Shaker Pan Frame Retrofit Kit

Part Number: 601342

WN-0105

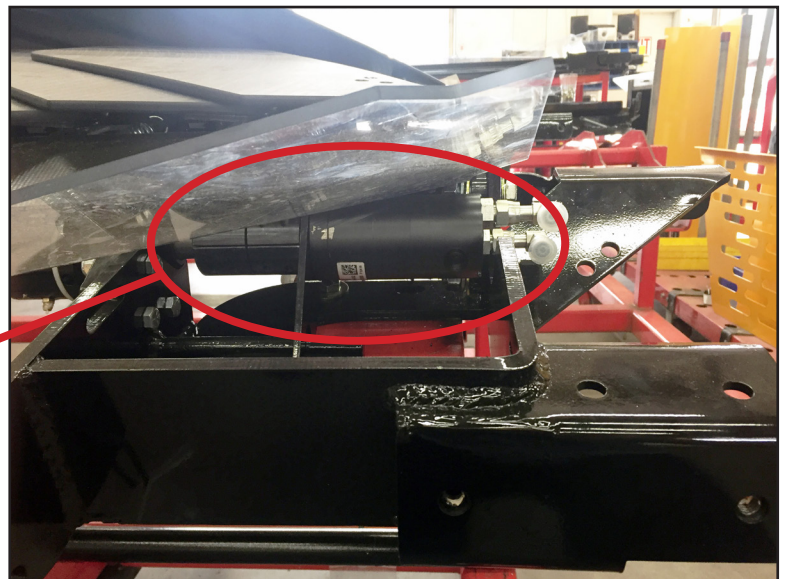
In the current design the shaker pan motors extend out the front of the frame weldment with no additional protection.

In the new design the shaker pan motor is set back into the frame with additional protection mounts.
